PROJECT ADDRESS: 601 MARKET STREET, KIRKLAND, WA
ID: DRV22-00693 DATE: DECEMBER 16, 2022 PAGE: 10

DESIGN REVIEW RESPONSE TO COMMENTS

1 Site Plan - Landscape Modification
Scale: 1/16" = 1'-0"

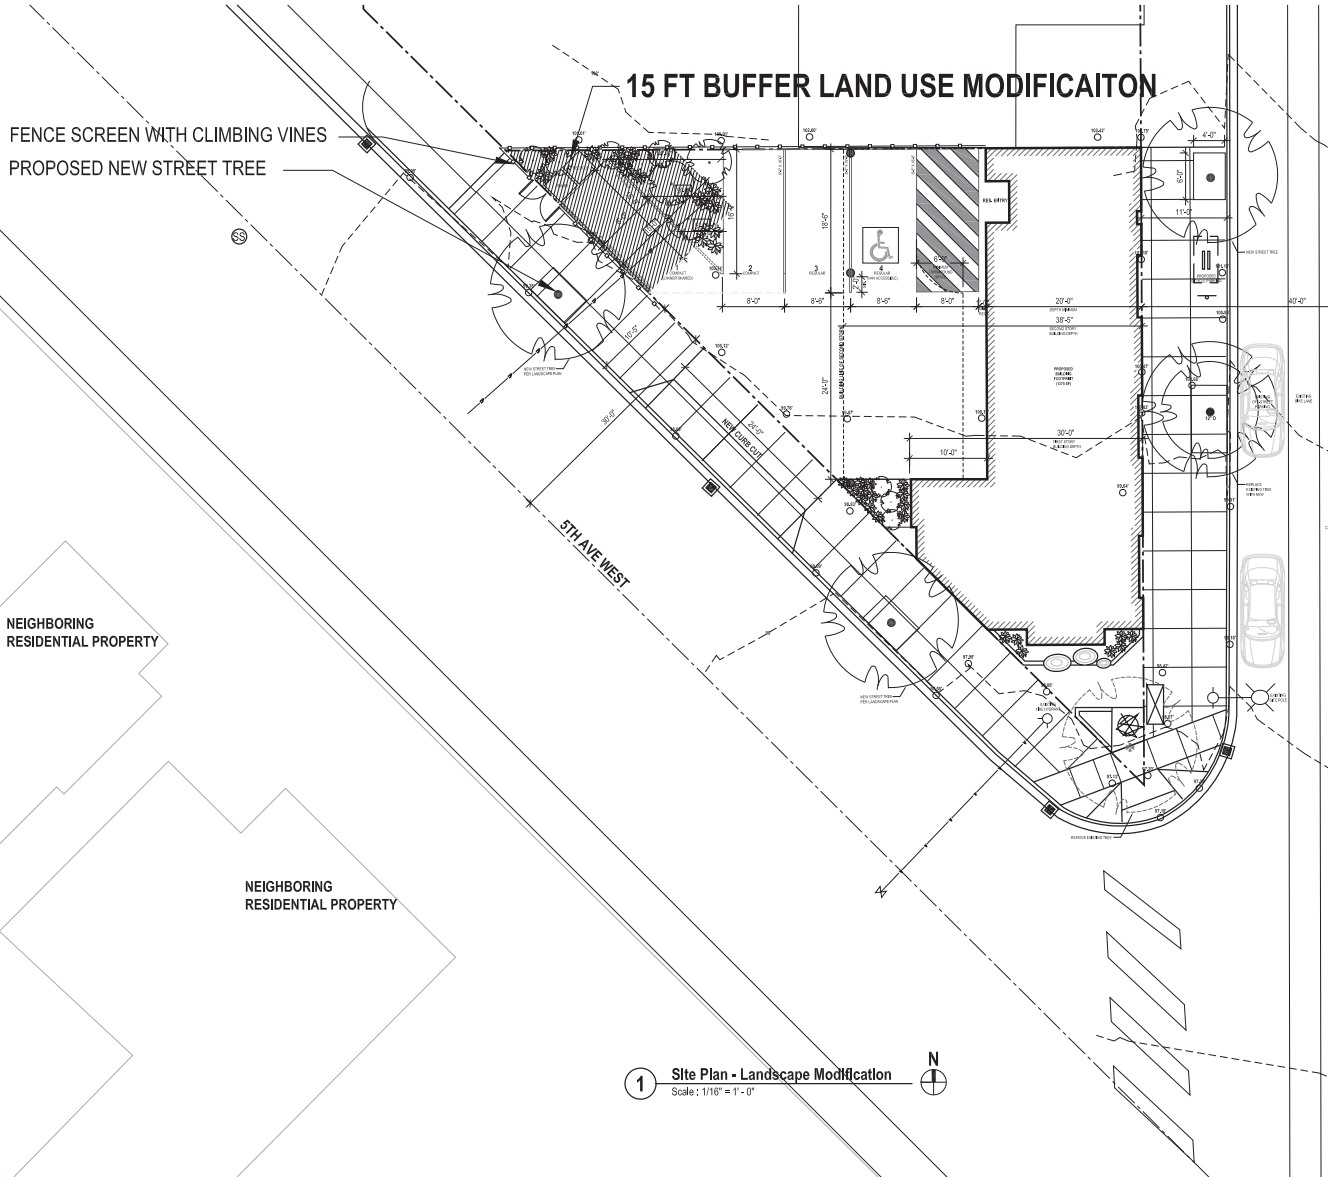
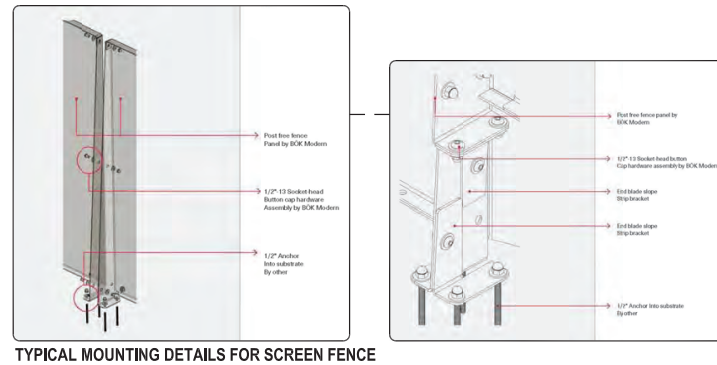
LAND USE MODIFICATION NARRATIVE: [KZC 95.42.2]

We are requesting a land use modification 95.46.(b) for the required 15 ft buffer at the parking off 5th Avenue. KZC 95.46.(b) states due to the existing topography, other characteristics of the subject property, and the distance of development from the neighboring property, we feel it decreases or eliminates the need for buffering.

Due to the challenging characteristics of the triangular site, we first obtained a parking modification **TRAN20-0057**. With the approved parking, we were able to derive our building footprint while meeting minimum requirements in the Kirkland Zoning Code.

The 15ft buffer would make parking infeasible due to the triangular site and required parking turn around radius, shown from the approved parking modification (TRAN20-0057), to buffer the neighboring residential homes across the street. The 15ft buffer would also make it infeasible to create a useable office space on the ground floor, as well as achieve the 20-30ft required building depth.

We have provided a 6ft fence with climbing vines and new street tree, and feel it will be sufficient to provide the visual buffer screen for those units. We have also provided an average of 9ft (or 5ft - 14.5ft) landscaping between the angled stall and the other stalls to provide as much landscape buffering as feasibly possible.

ELEVATIONS DESIGN REVIEW RESPONSE

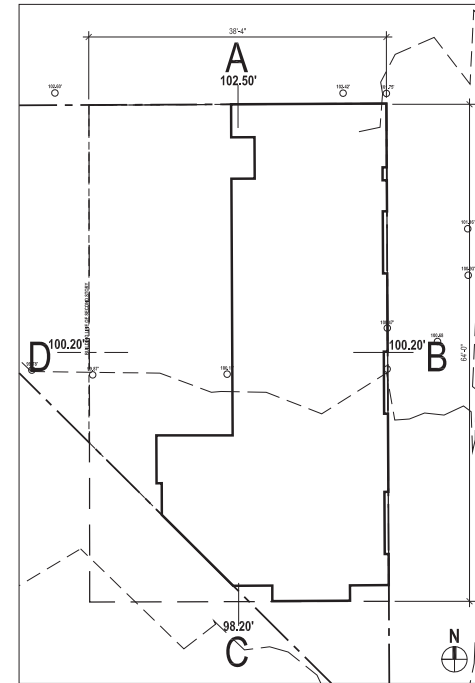
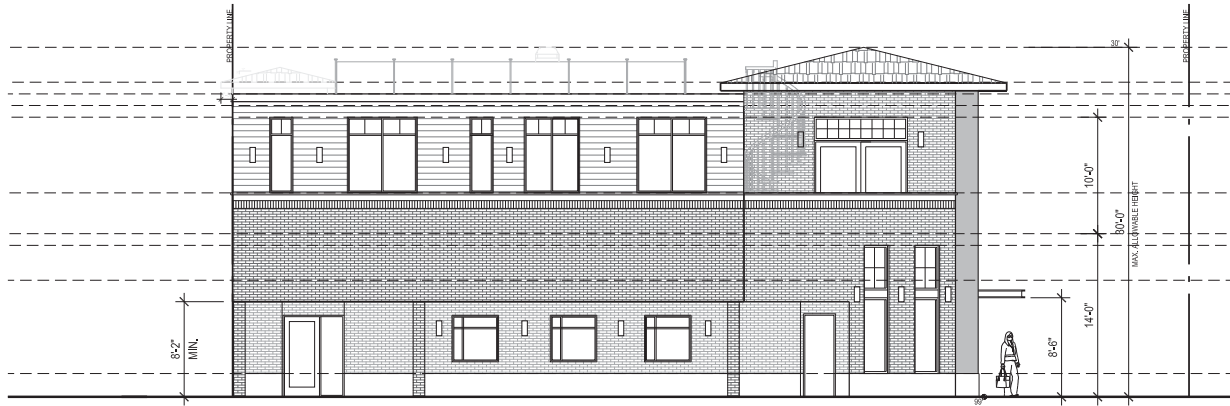
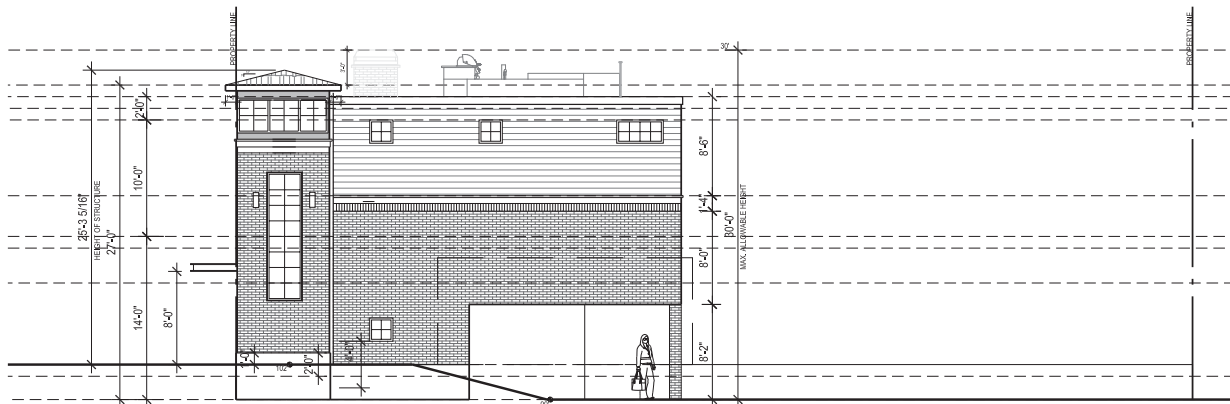
4. Properly show how grading of Market Street will impact building's elevations.
5. Discuss compliance with the rooftop appurtenances requirements (KZC 115.120) and provide details on screening, height, and aesthetics.

4. Detailed elevations that properly show the grade of Market Street and highlighting façade treatments, masonry patterning, colors, and material transactions from the office to the residential uses.

4. All elevations, especially the East elevation along Market Street is depicted in the proposal with accurate grade and dimensions along with how the masonry base would transition as the grade increases to the North.

SECTIONS DESIGN REVIEW RESPONSE

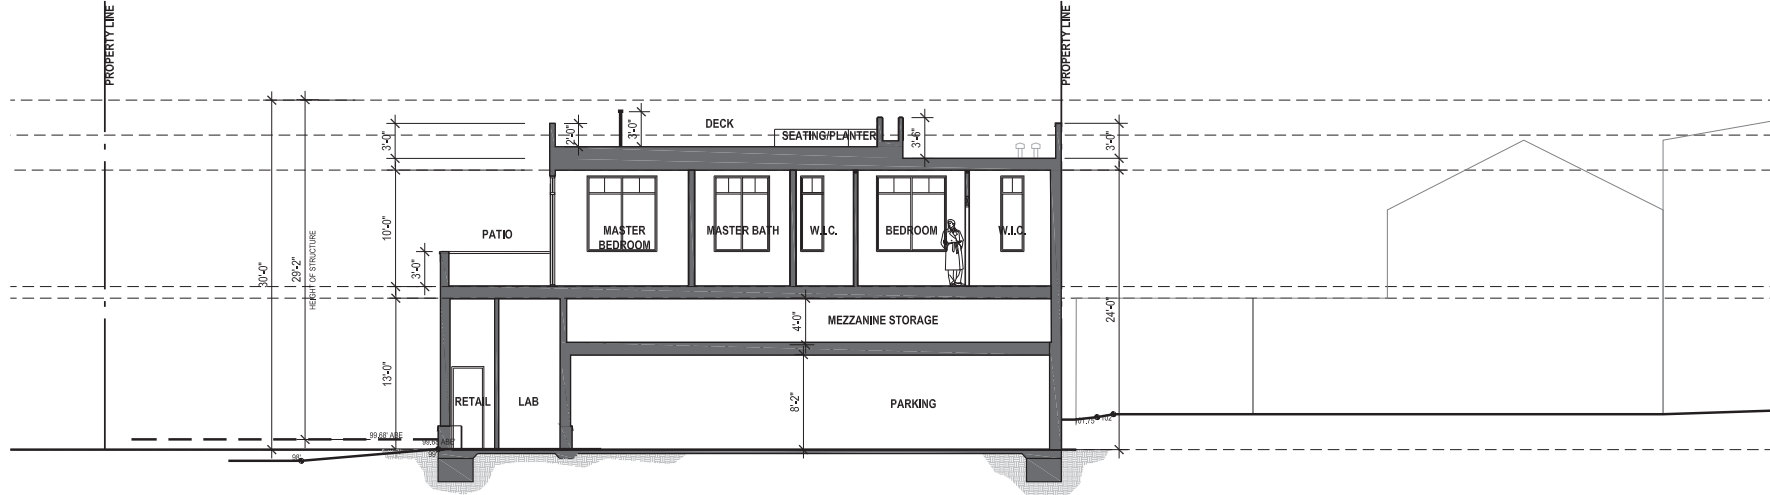
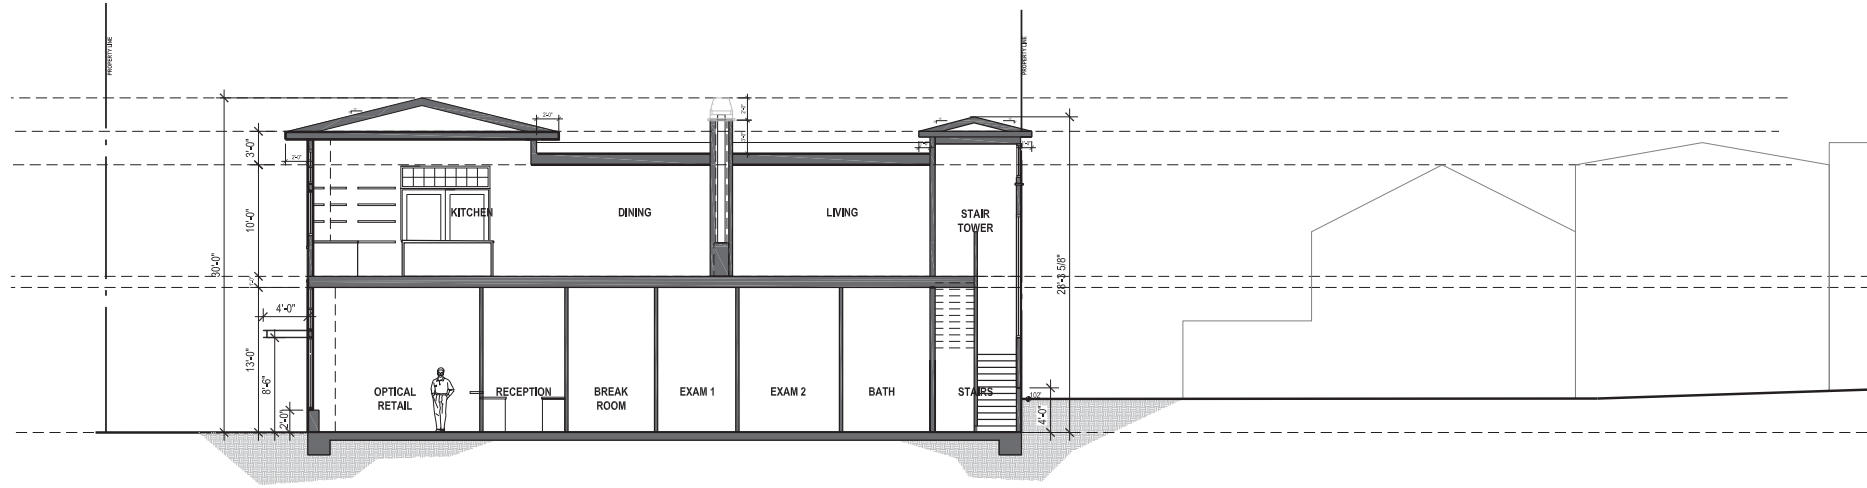
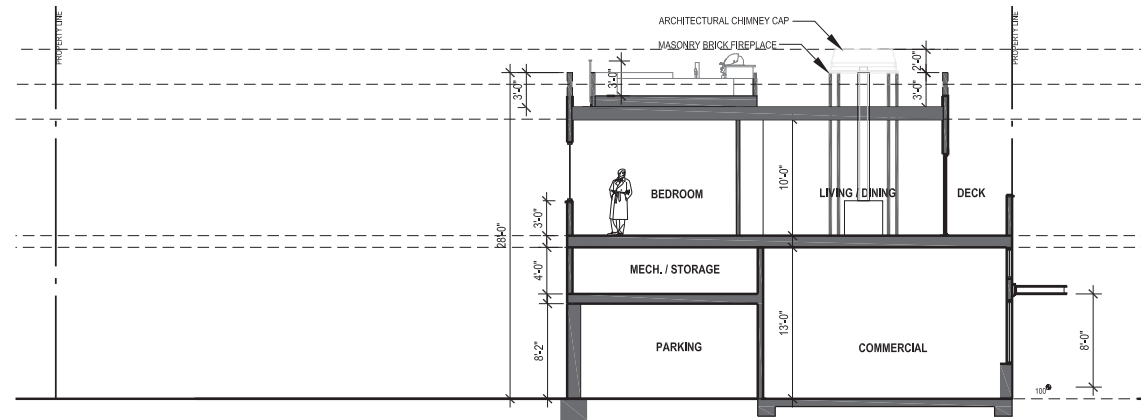
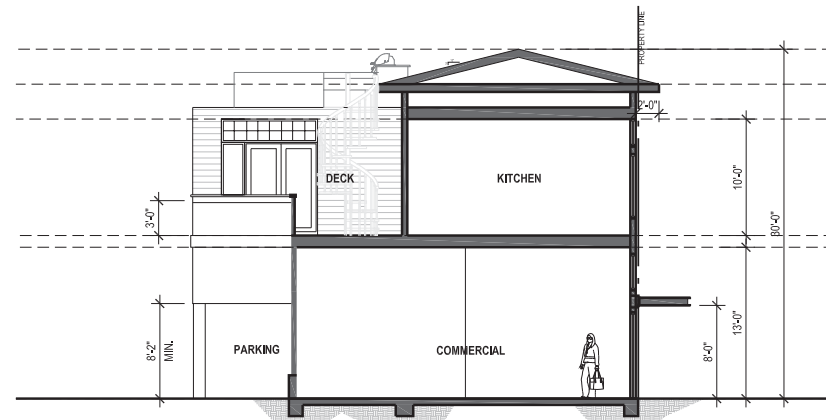
6. Include building sections showing not only the proposed structure, but also neighboring buildings.
7. Finalize the landscape plan making sure to focus on the parking screening required landscape buffers, and the pedestrian space.

6. Building sections have been included in the proposal and show the neighboring buildings.

FIGURE 95.45.B

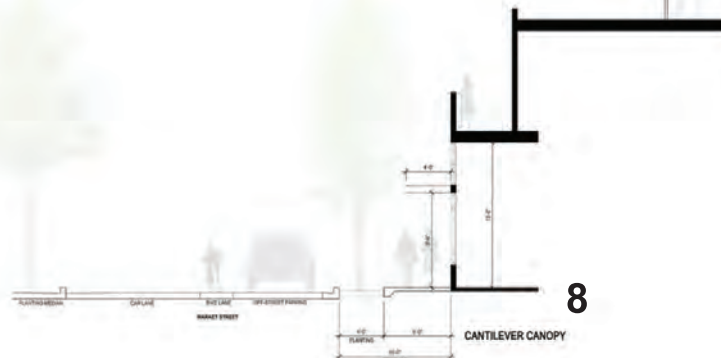
The property is also subject to vegetative buffer standards per KZC 95. The Board discussed these regulations and identified a need for detailed and effective screening to comply with KZC 95 and the Design Guidelines for the Market Street Corridor.

The vegetative buffer complies with KZC 95 as a 5ft landscaping screen wall along the parking is provided, similar to what is shown in fig. 95.45.B.

7. The landscape buffer exhibit, landscape screen wall fence detail sheet, and the landscape plan are included in the proposal. Parking screening to comply with Fig. 95.45.B, with 5ft high landscaped fencing and climbing vines.

PHOTOMETRICS - SITE PLAN

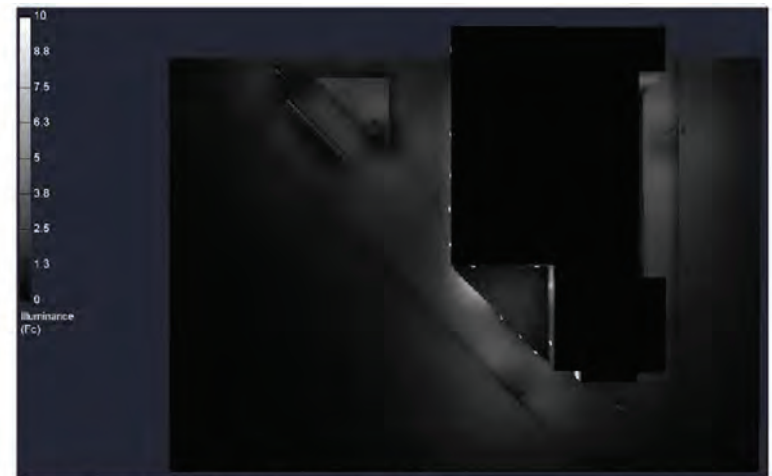
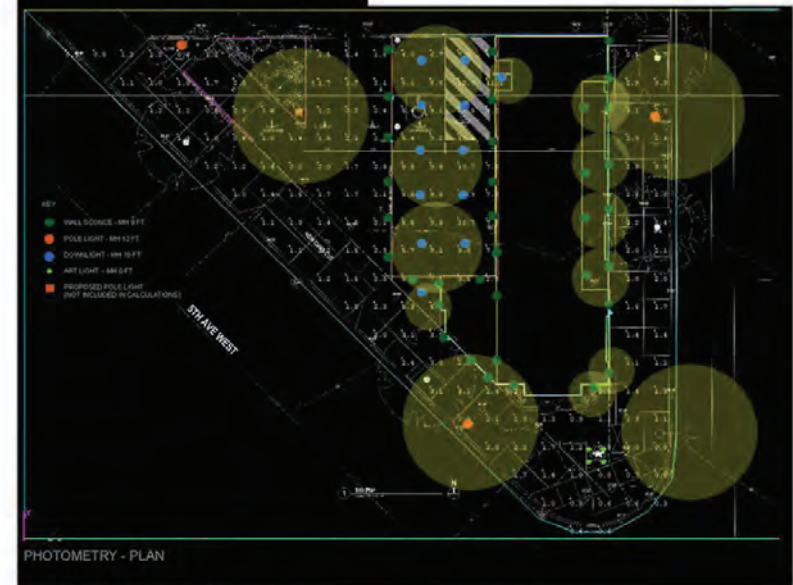
3. Art installation from a local artist.
4. Installation of bike parking on Market Street to best support the existing bike lane.
5. All building entries should be well lit. Building facades in pedestrian areas should provide lighting to walkways and sidewalks through building-mounted lights, canopy, or awning-mounted lights, and display window lights. Encourage variety in the use of light fixtures to give visual variety from one building façade to the next. Backlit or internally lit translucent awnings should be prohibited.

Lighting photometrics are presented to show optimal site lighting in the parking, 5th Ave. W., and Market Street, as well as, along the building facade and upper terraces.
